HISTORIC AND DESIGN REVIEW COMMISSION

September 07, 2022

HDRC CASE NO: 2022-430
ADDRESS: 130 KING WILLIAM
LEGAL DESCRIPTION: NCB 737 BLK 2 LOT 7 & 8
ZONING: RM-4, H, HL
CITY COUNCIL DIST.: 1
DISTRICT: King William Historic District
LANDMARK: Individual Landmark
APPLICANT: Marques White/Legacy Home Improvements
OWNER: SAN ANTONIO ART LEAGUE
TYPE OF WORK: Porch roof replacement with pitch change
APPLICATION RECEIVED: July 17, 2022
60-DAY REVIEW: Not applicable due to City Council Emergency Orders
CASE MANAGER: Jessica Anderson

The applicant requests a Certificate of Appropriateness for approval to replace the flat membrane roof of the wraparound porch with a pitched standing-seam metal roof.

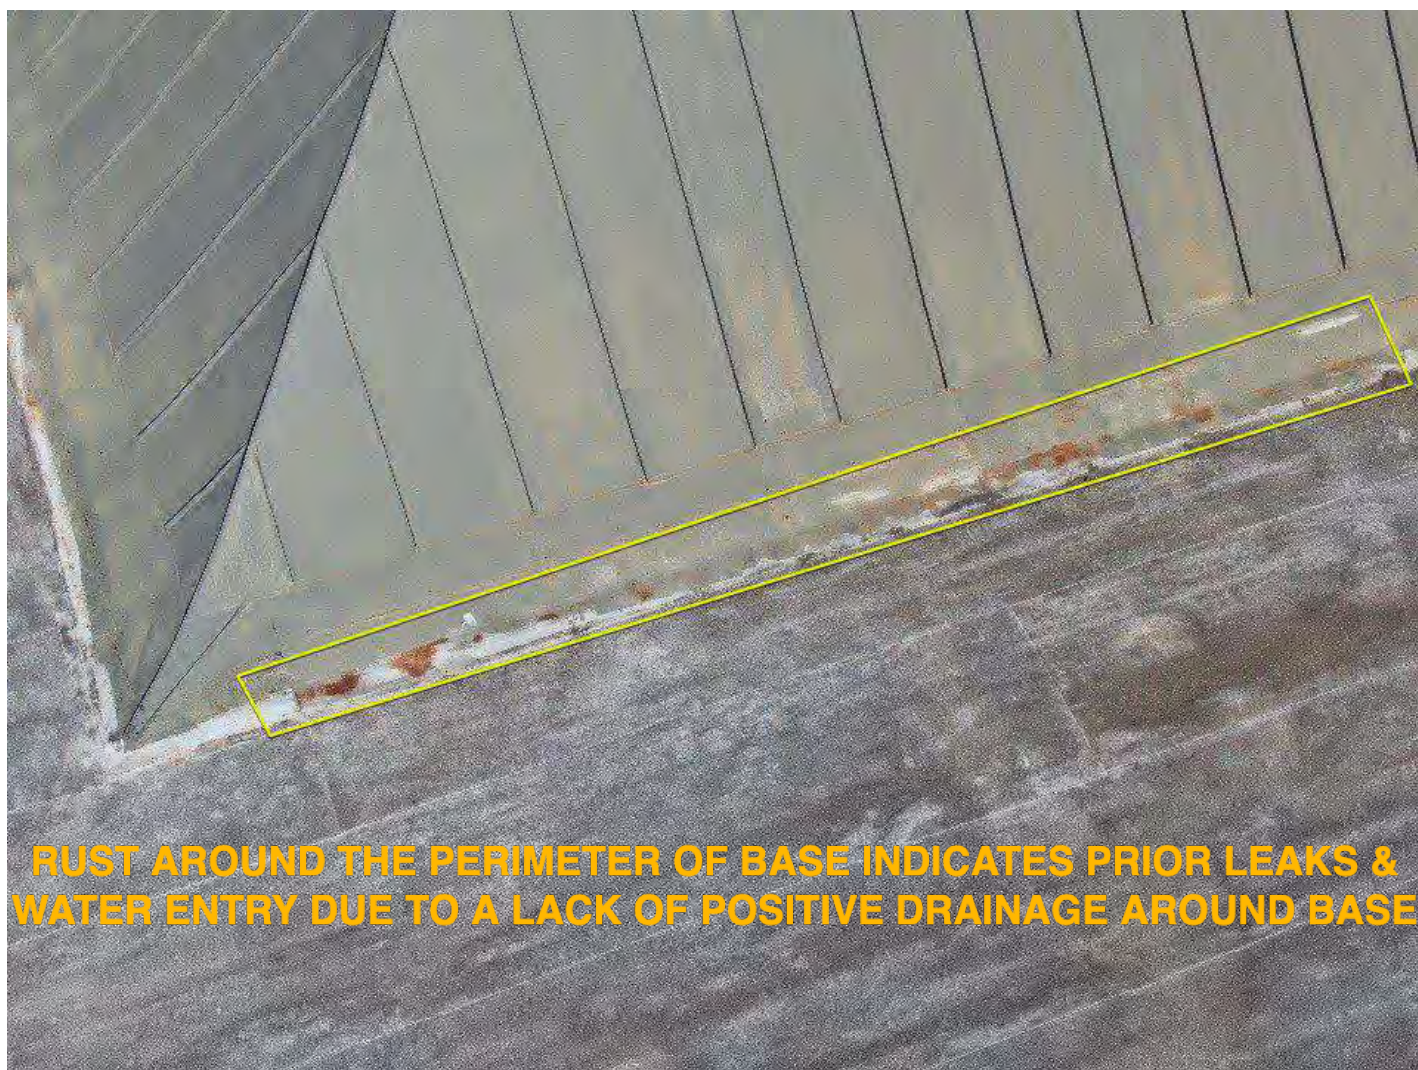
To quell any potential concern of there being a noticeable change in aesthetic due to the proposed pitch change at 130 King William, we took photos from about 9ft high from various locations around the property. As you can see, the bottom ½ of the more than 12' high crown portion of the roof is completely invisible in some photos taken from across the street, and in the photos taken closer or on the property, the crown cannot even be seen at all.

To achieve our minimal pitch transition just 20" inches (less than 2 feet) above the current base which will decline toward the eave from there. This minimal change would provide much needed positive drainage and peace of mind for the museum, while remaining non-noticeable from street level, with many feet to spare in that regard. This minor change will undoubtedly meet the committee's request to include a low enough profile as to not be visible from the public right-of-way, while maintaining historical design and protecting & preserving the building.

A3.1

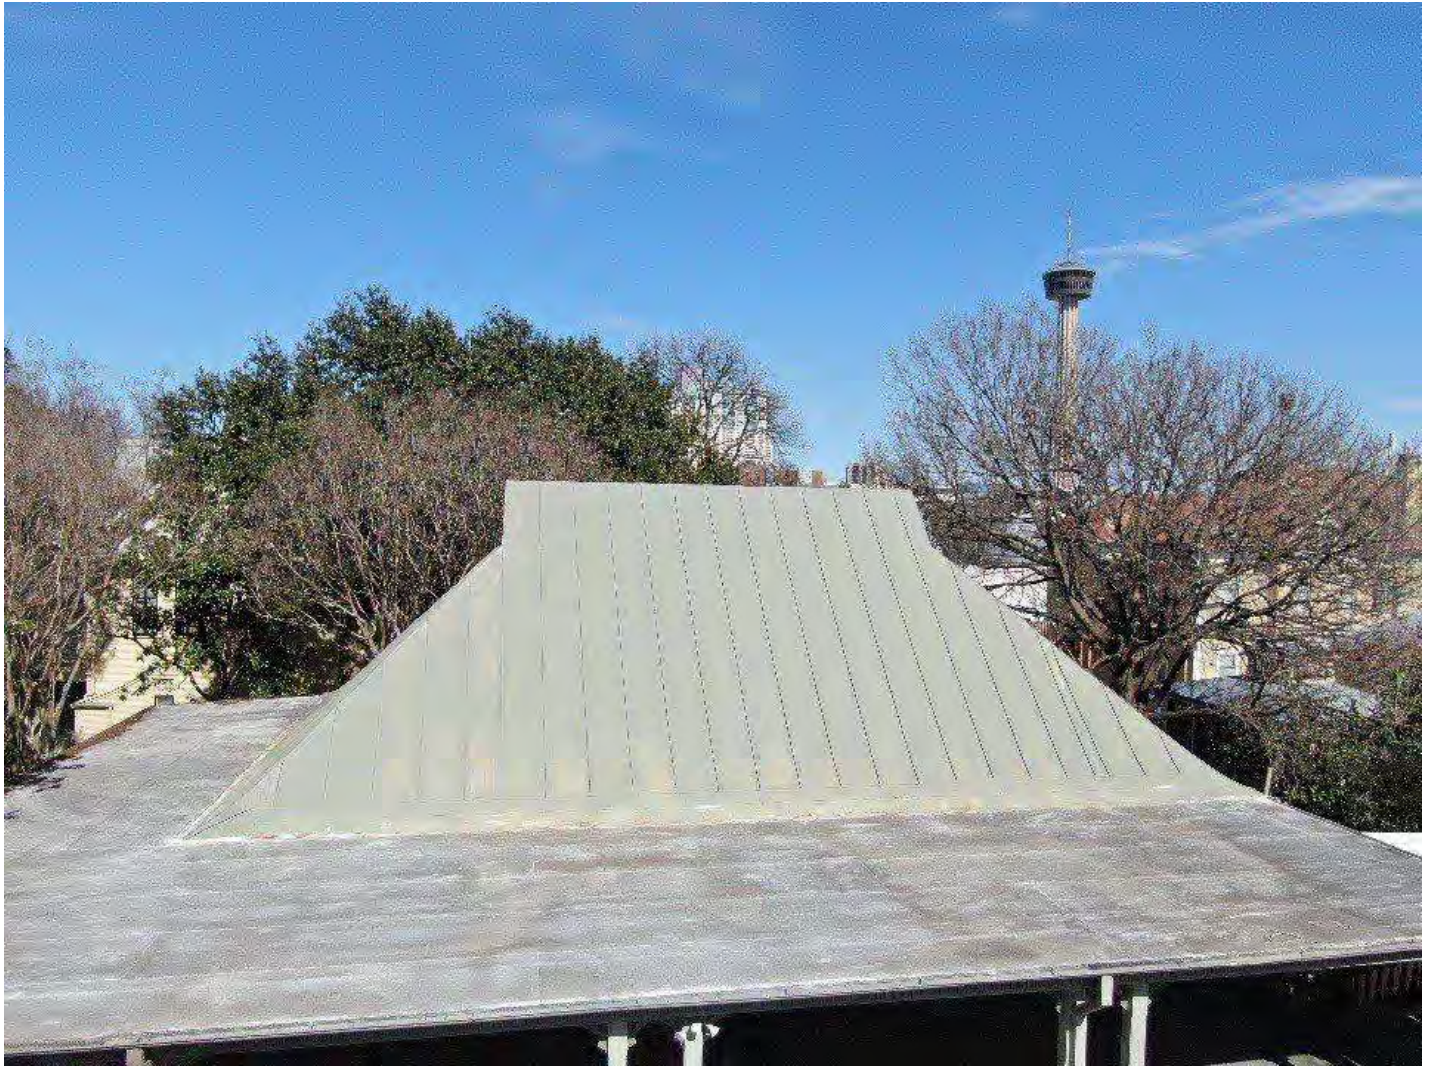
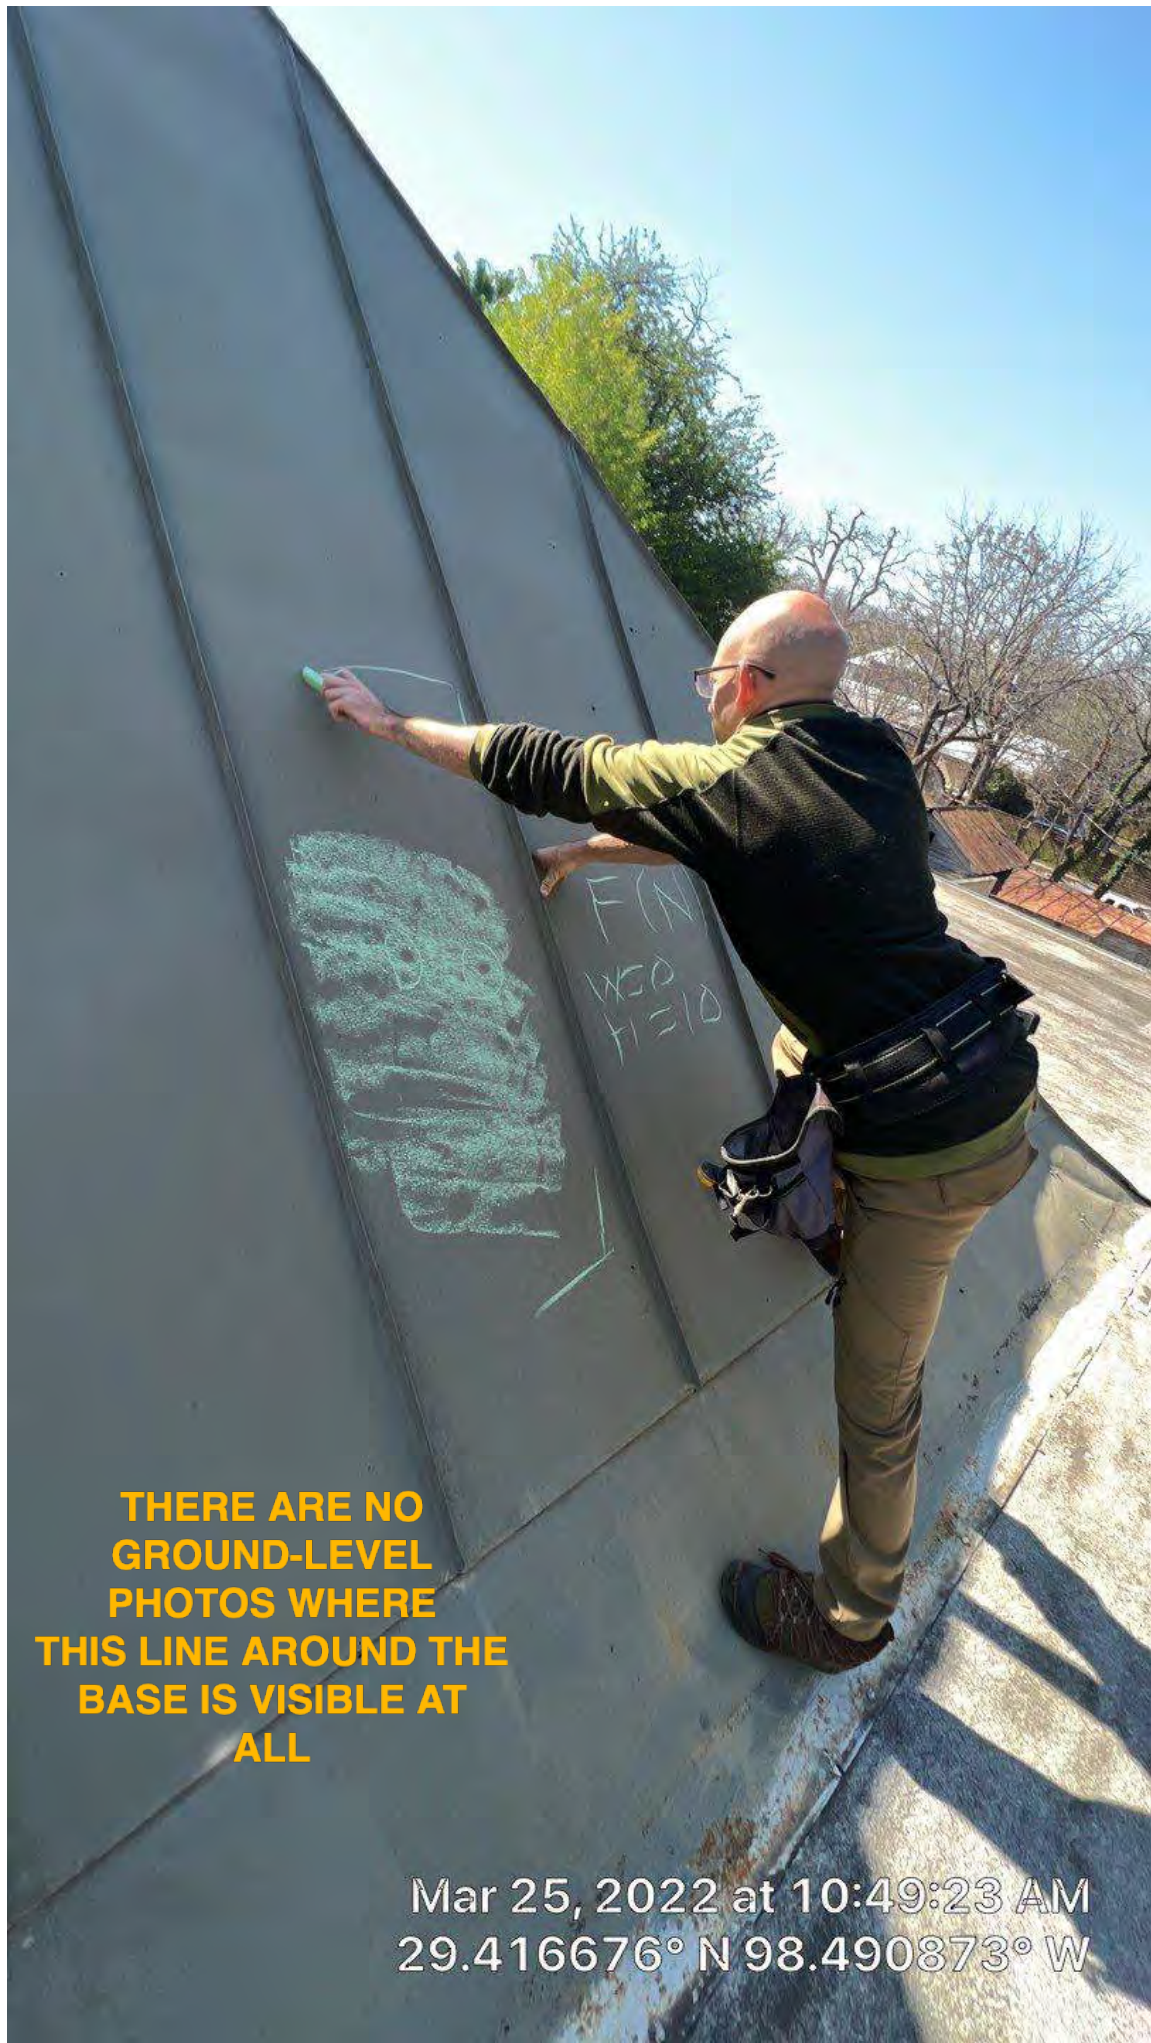
The King William Association Architectural Advisory Committee reviewed the staff findings and recommendations and suggest that the application be approved the slightly increase the porch roof pitch to improve drainage and eliminate roof leaks. Joints where flat membrane roofs intersect pitched metal roofs are prone to leak and should be avoided. The applicants proposed increase in the pitch of the porch roof will allow the installation of metal flashings to join the existing standing seam roof to a new standing seam porch roof. We concur with the applicants assessment that this slight change in pitch will not be visible, however we suggest that the applicant incorporate hip conditions at the porch ends in lieu of the visible "walls" indicated on the roof plan sketch.

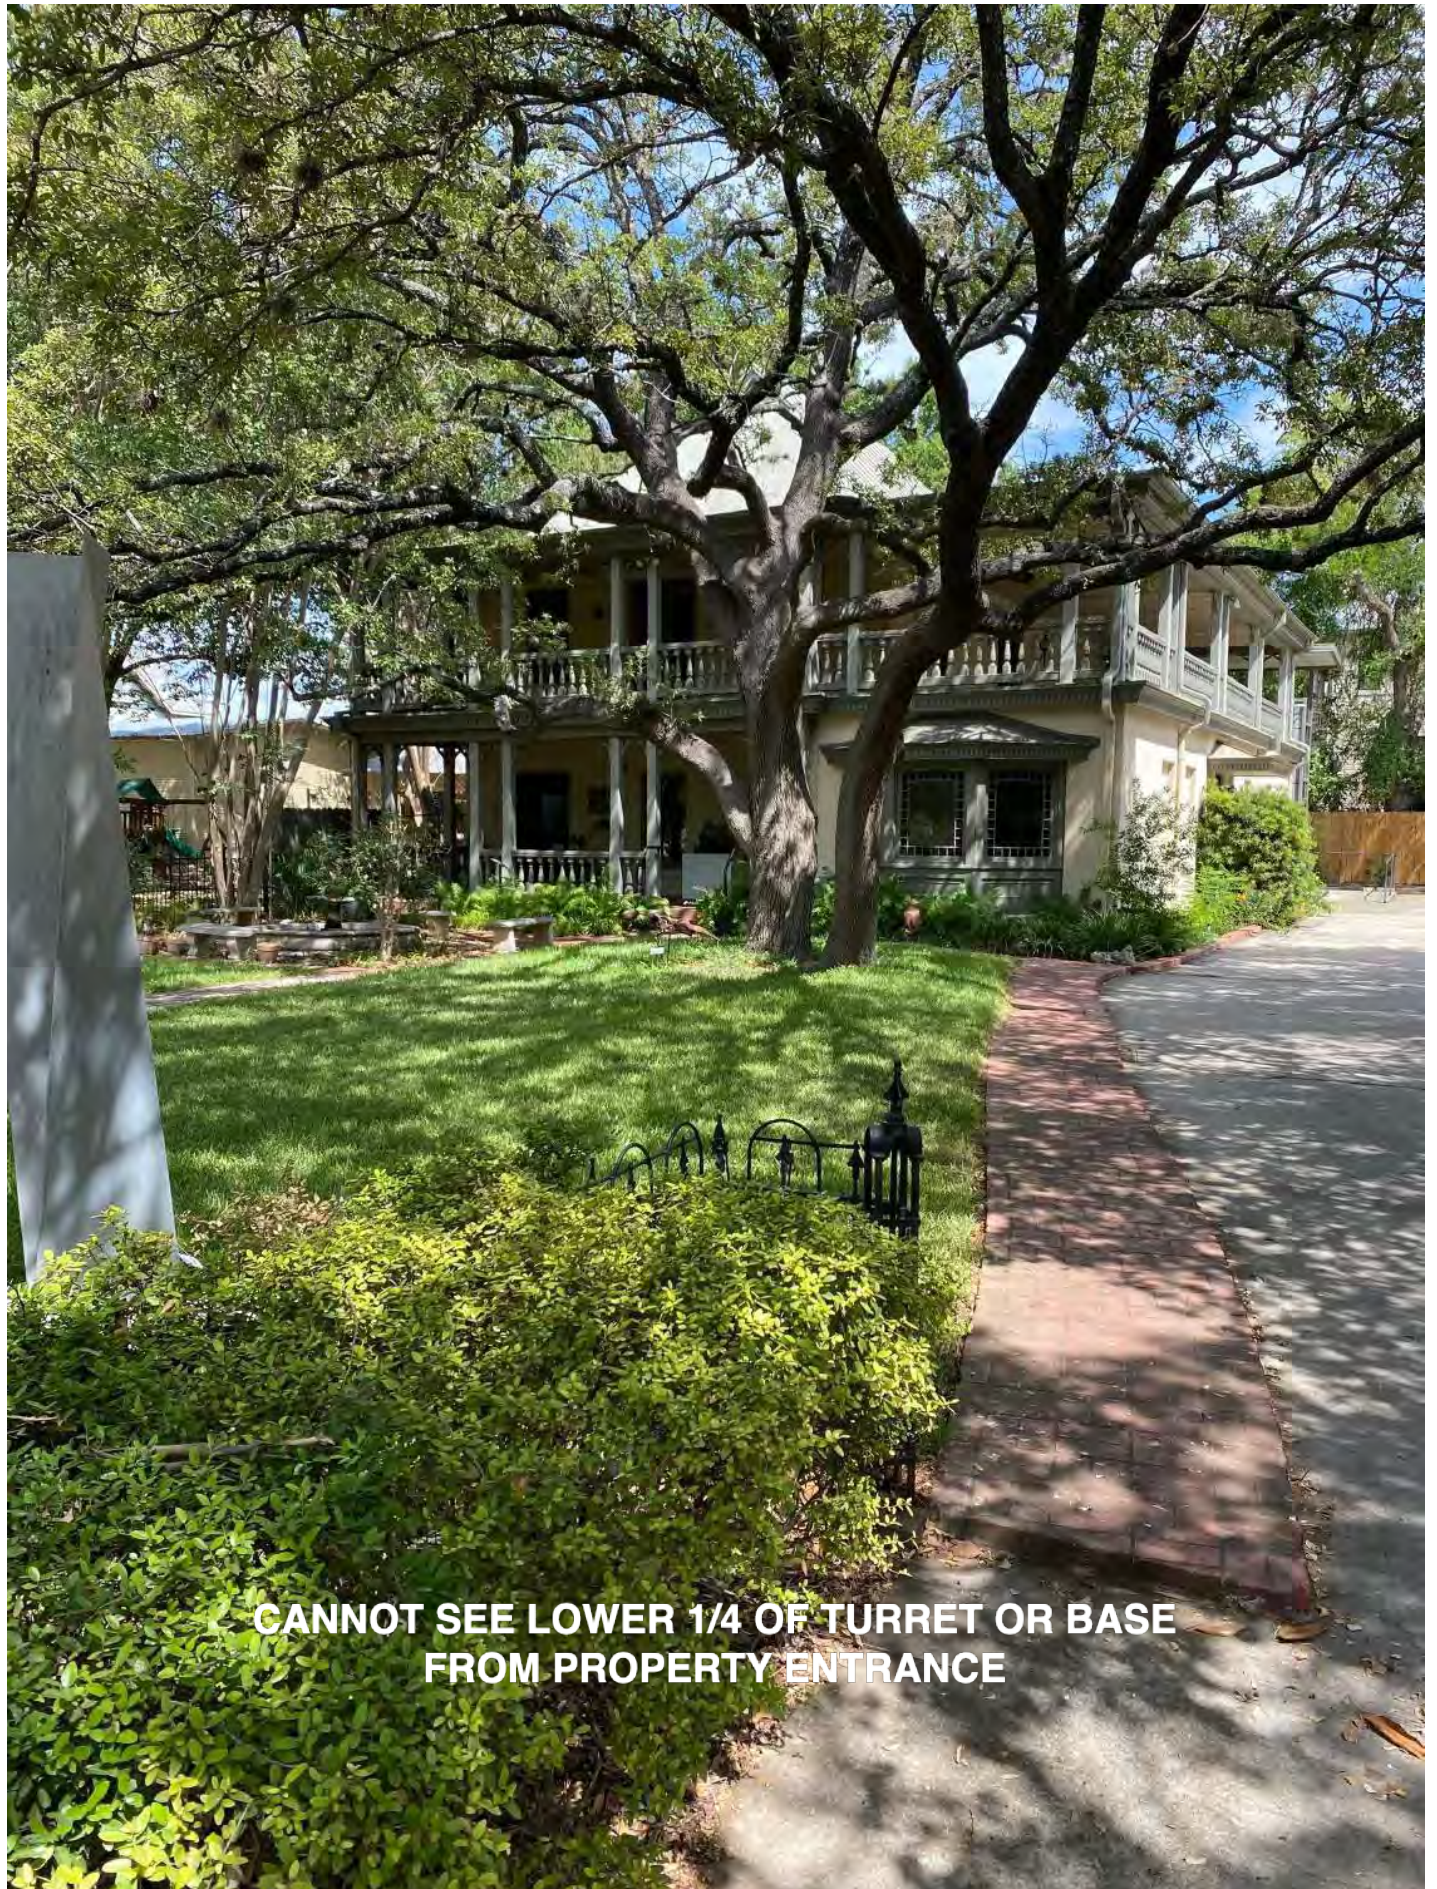
**FRONT VIEW FROM ACROSS THE STREET
THE LOWER HALF OF THE TURRET CANNOT BE SEEN FROM THE PUBLIC
RIGHT OF WAY**

**FRONT VIEW FROM ACROSS THE STREET
THE TURRET CAN BARELY BE SEEN FROM THE PUBLIC RIGHT OF WAY**

**CANNOT SEE LOWER 1/4 OF TURRET OR BASE
FROM PROPERTY ENTRANCE**

**VIEW FROM NEXT BUILDING
TOP OF TURRET BARELY SEEN**
